SUBJECT: NuScale Power, LLC Submittal of the Approved Version of NuScale Topical Report TR-0116-20825, "Applicability of AREVA Fuel Methodology for the NuScale Design," Revision 1 (NRC Project No. 0769)

SUBJECT: FINAL SAFETY EVALUATION FOR NUSCALE POWER, LLC TOPICAL
REPORT-0116-20825, REVISION 1, "APPLICABILITY OF AREVA FUEL
METHODOLOGY FOR THE NUSCALE DESIGN"

**TOPICAL REPORT-0116-20825, REVISION 1, “APPLICABILITY OF AREVA FUEL
METHODOLOGY FOR THE NUSCALE DESIGN”**

Figure 6-1: Bow Effect Parameter ($\delta_{\text{bow, meas}}$) as a Function of Local Mass Velocity

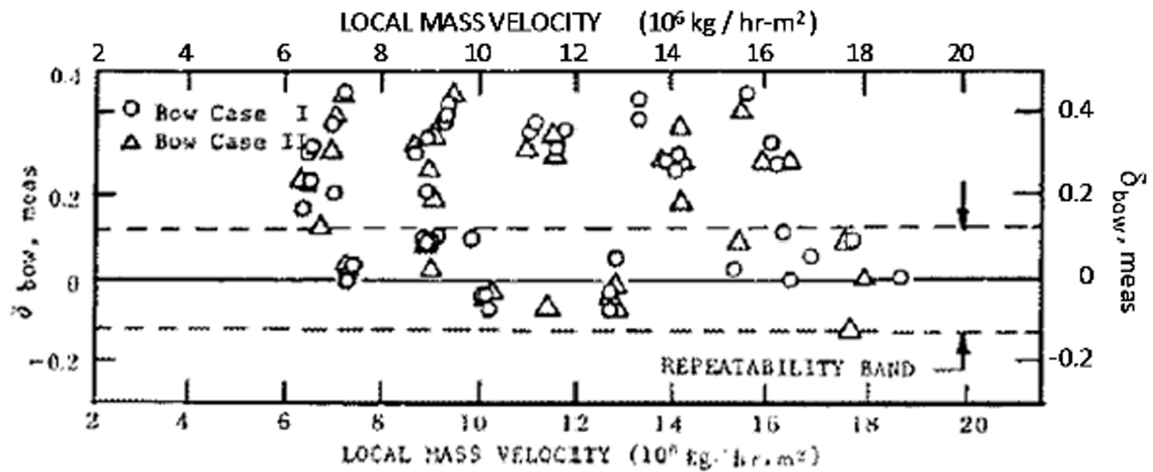
The nominal operating conditions for the NuScale core are approximately a pressure of 126 ata, a mass velocity of 2.2×10^6 kg/hr-m², and an inlet temperature of 256 degrees-C. These NuScale operating conditions are within the range of test conditions examined with the exception of the mass velocity which is approximately 1/3 of the minimum mass velocity tested. Figures 6-1 and 6-2 are provided that show the parameter of $\delta_{\text{bow}, \text{meas}}$ as a function of local mass velocity and pressure, respectively (Reference 9). The $\delta_{\text{bow}, \text{meas}}$ parameter effectively normalizes out any trends in the data except those due to the presence of the fuel rod bowing and to random scatter.

Although the NuScale nominal mass velocity is below the minimum local mass velocity in the tested conditions, the trend in mass velocity at the lower mass velocity region in the figure is small as the NuScale nominal mass velocity is approached.
